**SERVICE BULLETIN**

**APPLICABILITY:** 2019-24MY Forester  
 2025MY Forester Wilderness

**NUMBER:** 07-218-23R

**SUBJECT:** Genuine Alternative Battery Replacement

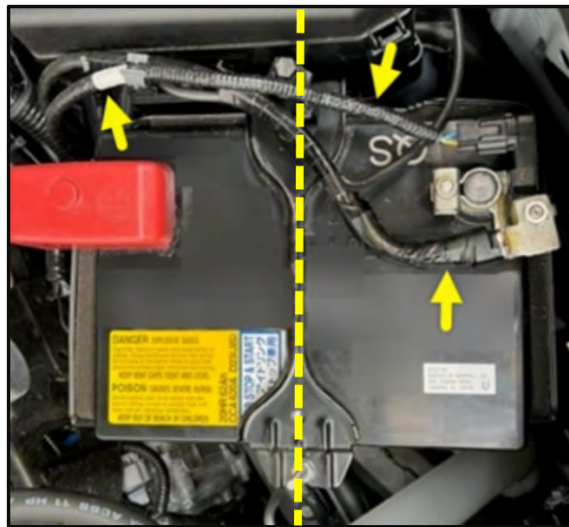
**STEP 4:** Install the NEW battery cover (p.n. 82123AN000) to the alternative replacement battery. Confirm the bottom of the cover is aligned flush with the bottom of the battery.
